To: T10 Technical Committee  
From: Rob Elliott, Compaq Computer Corporation (Robert.Elliott@compaq.com)  
Date: 16 April 2002  
Subject: T10/02-134r0 SAM-2 SPC-3 SBC-2 SSC-2 Clearing effects of I\_T nexus loss

T10/02-134r1 SAM-2 SPC-3 SBC-2 SSC-2 Clearing effects of I\_T nexus loss

**Figure 1. Power on, hard reset, logical unit, and I\_T nexus loss relationships**

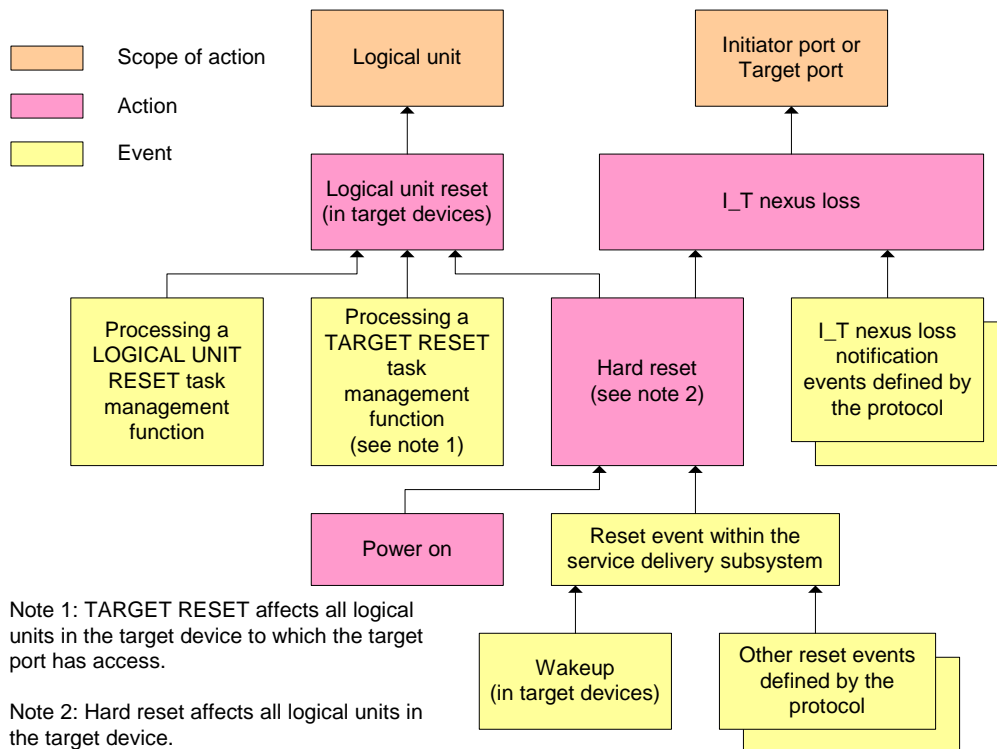
**5.8.t Power on, hard reset, logical unit reset, and I\_T nexus loss**

Figure 1 shows the relationships between power on, hard reset, logical unit reset, I\_T nexus loss, and their associated notification events.
